Docket Item #4 A-F
EESAP Blocks 11 & 12 - 2210 Eisenhower Avenue

Application	General Data	
Project Name: Eisenhower East Blocks 11 & 12	PC Hearing:	April 6, 2010
	CC Hearing:	April 17, 2010
	If approved, DSUP expiration:	April 17, 2013 (36 months)
	Site Area:	Block 11: 126,010 sf (2.89 ac) Block 12: 59,653 sf (1.37 ac)
Location: 2210 Eisenhower Avenue	Zone:	CDD#2
	Proposed Use:	Residential & Retail
	Gross Floor Area:	Block 11: 674,259 sf Block 12: 641,964 sf Total: 1,317,304 sf
Applicant: Hoffman Company, LLC by Kenneth Wire, McGuireWoods LLP	Small Area Plan:	Eisenhower East
	Green Building:	LEED Certified or 1 Green Globe (& min. 40% of possible Green Globes points)

Purpose of Application
 Stage 2 DSUP approval for development of two blocks in the *Eisenhower East Small Area Plan* area. The proposal includes two residential/retail mixed-use buildings on the east side of the Eisenhower Avenue Metro Station, name approvals for two new public streets – Anchor Street and Swamp Fox Road – and the new Eisenhower Station Square at the renovated Eisenhower Avenue Metro Station.

DSUP2009-0004

Illustrative F: Staff Alternate Ground Floor Plan - Expanded Retail Space shown in blue
 Note that retail elevator location gives direct access to Eisenhower Avenue and lease space.

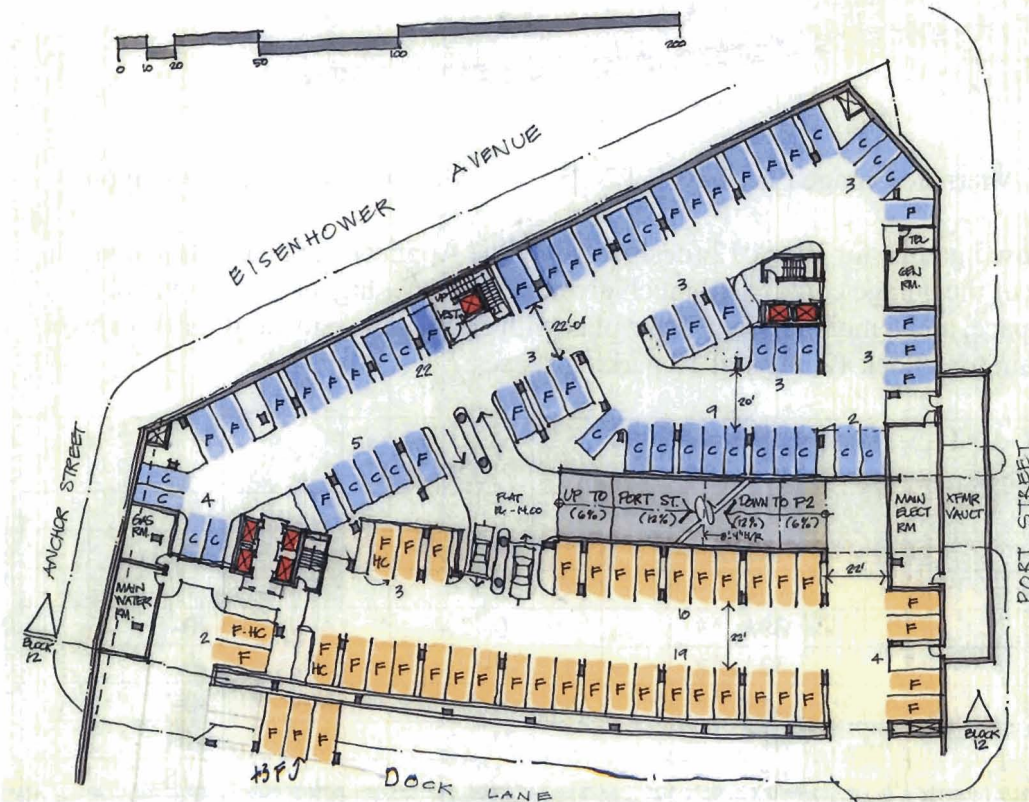
Parking/Open Space Issue on Block 12:

opportunities for future restaurants in Block 12, and is also large enough to accommodate retail kiosks, such as the ones found in Bryant Park and elsewhere in Manhattan. The plan changes also allow for greater retail depth (an industry-standard 70-80 feet, versus the 50 feet shown in the current proposal,) and the elevator location – close to Eisenhower Avenue - allows for complete flexibility in retail tenant sizes (versus the current proposal, which requires a passageway at some point, cutting the retail space in half.) This consolidated retail space gains substantial exposure as well, since it would also be visible *and* accessible from the newly-created open space, and its single parking entrance on Port Street is immediately visible to anyone coming to the retail, whether from Southern Street, Dock Lane or Eisenhower Avenue eastbound or westbound. Replacing the two ramps on Dock Lane with a single entry on Port Street also adds a significant number of on-street parallel parking spaces on Dock Lane (from 11 to 17.) Elimination of the above-grade parking structure also allows increased efficiency by relocating tenant and leasing office spaces currently shown on a single-loaded corridor on the second floor facing Port Street to the main building corridor, along with a net gain of 3 – 4 additional dwelling units, and elimination of an exit stair necessitated by the long dead-end corridor in the current proposal. Finally, removal of three levels of mechanically-ventilated garage would save total construction costs in the neighborhood of \$4 million. While these changes would involve some minor adjustments to column and core locations in Block 12, it should be noted that this piece of the project has been identified by the Applicant as Phase II, and there is therefore ample time to make these design changes without impacting the construction schedule for the overall project.

Illustrative I: Staff Alternate 2nd Floor Plan – Replaces Single-Loaded Condition with Double-Loaded

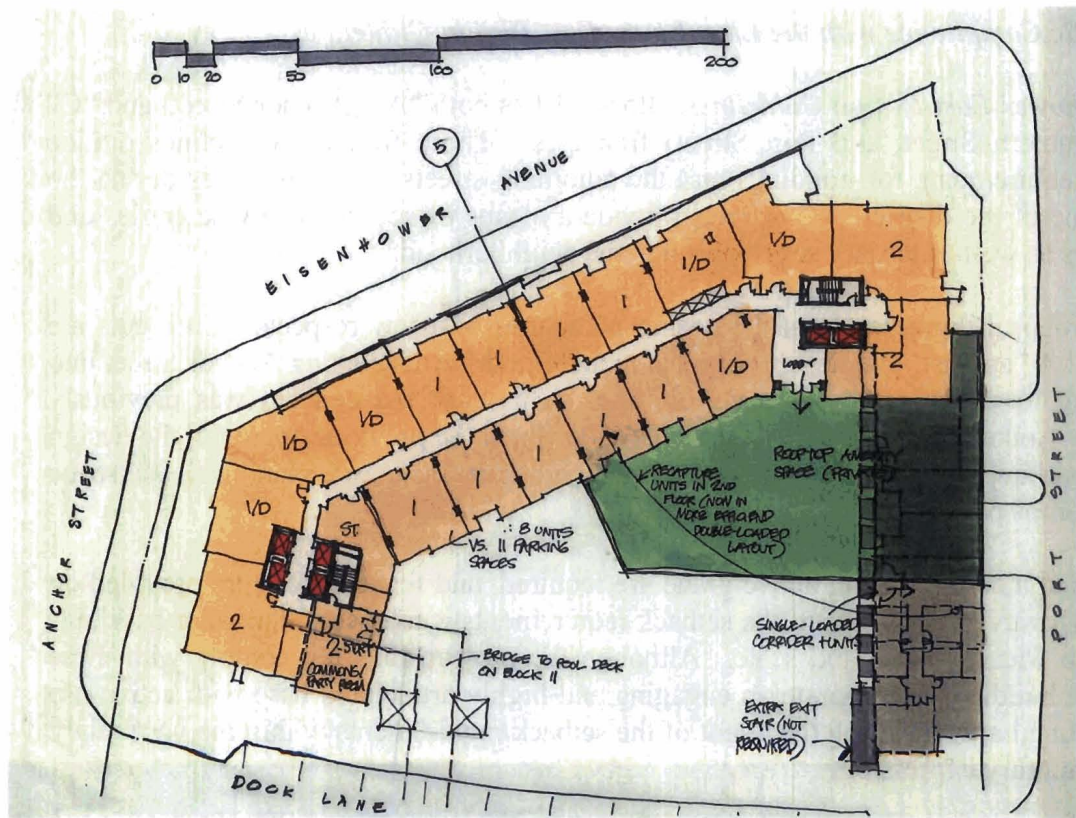
*) Applicant proposes a total of 95 cars on three above-grade levels - totaling approximately 65,000 square feet, which translates into \$3.5 to 5 million of construction. In

addition, this parking is very inefficient (over 750 square feet per car, versus a standard of around 350 square feet each.) The area freed up by elimination of the above-grade parking can provide over one-third of an acre of ground-level open space. The area on the 2nd floor formerly occupied by garage can then be used for additional residential units (yielding several additional units, and eliminating a redundant exit stair and long single-loaded corridor.)

**) Applicant proposes 53 retail spaces on two separate, small levels, which makes searching for a parking space difficult; staff proposal provides 54 retail spaces on a single level, with one-stop elevator connection to retail shops and Eisenhower Avenue.
